COUNCIL ASSESSMENT REPORT

Panel Reference	2018SNH002
DA Number	2017/503
LGA	WILLOUGHBY
Proposed Development	DEMOLITION OF 2 COMMERCIAL BUILDINGS, RECONSTRUCTION AND EXPANSION OF CHATSWOOD CHASE SHOPPING CENTRE.
Street Address	345 Victoria Avenue, 12-14 Malvern Avenue and 5-7 Havilah Street, CHATSWOOD NSW 2067
Applicant/Owner	Vicinity Centres PM Pty Limited
Date of DA lodgement	21-DEC-2017
Number of Submissions	17
Recommendation	DEFERRED COMMENCEMENT APPROVAL
Regional Development Criteria (Schedule 7 of the SEPP (State and Regional Development) 2011	YES
List of all relevant s4.15(1)(a) matters	<ul style="list-style-type: none"> relevant environmental planning instruments relevant development control plan
List all documents submitted with this report for the Panel's consideration	<ul style="list-style-type: none"> plans
Report prepared by	MARK BOLDUAN
Report date	7/12/2018

SNPP REPORT

RECOMMENDATION: DEFERRED COMMENCEMENT APPROVAL

Figure 4: Maximum height development standard within the site (extract from WLEP Height of Building map)

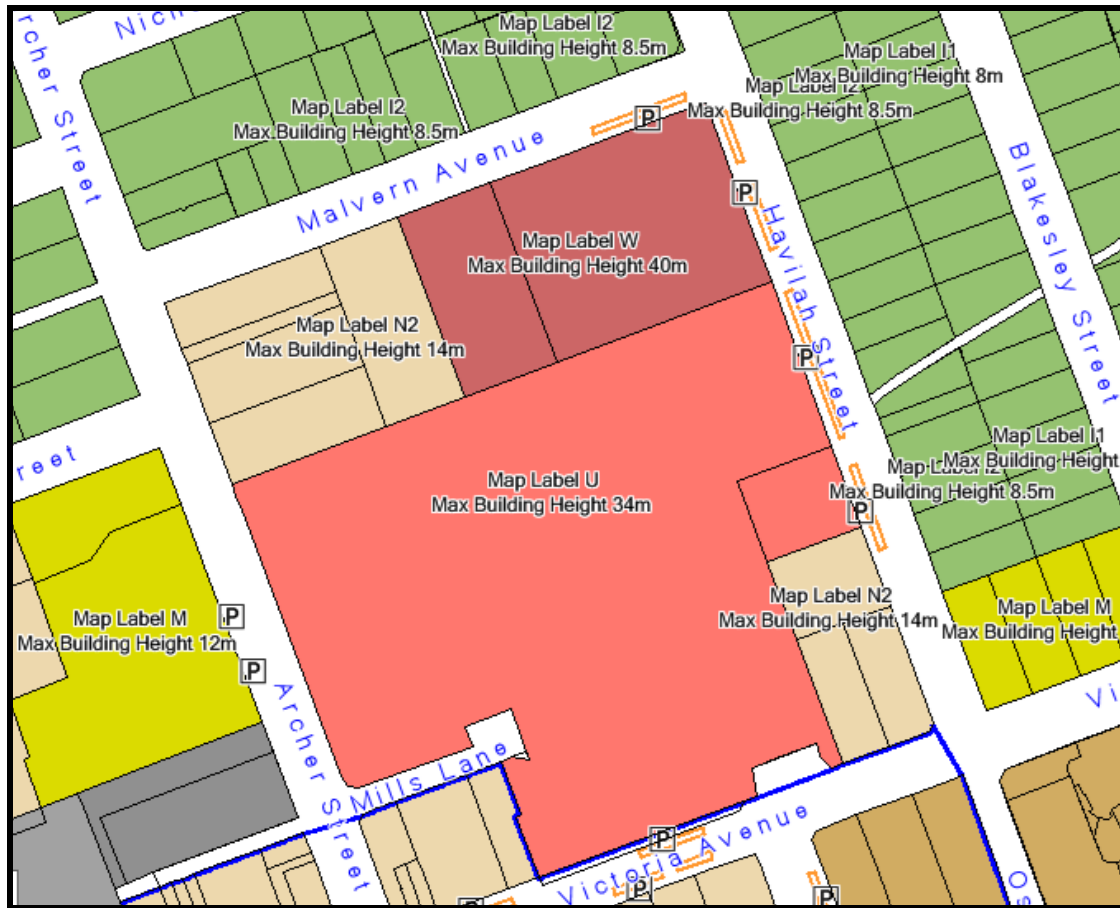
The following extract of the WLEP 2012 Height of Buildings map (Figure 4 below) indicates that the areas of the site which have a maximum height of 34m and the areas have a maximum height of 40m.

The eastern elevation plan (DA 2200) indicates that, in that part of the site with an existing ground level of RL 80.00 (see surveys), the building attains an elevation of RL 114.25. That is a building height of 34.25m. Furthermore, there are small projections above RL 114.25. This is a non-compliance with Clause 4.3.

Figure 4 also indicates the northern areas of the site that have a maximum building height standard of 40m. The eastern elevation plan (DA 2200) indicates that, in that part of the site with an existing ground level of RL 81.50 (see surveys), the building attains an elevation of approximately 121.5m. That is a height of 40m, which complies with Clause 4.3.
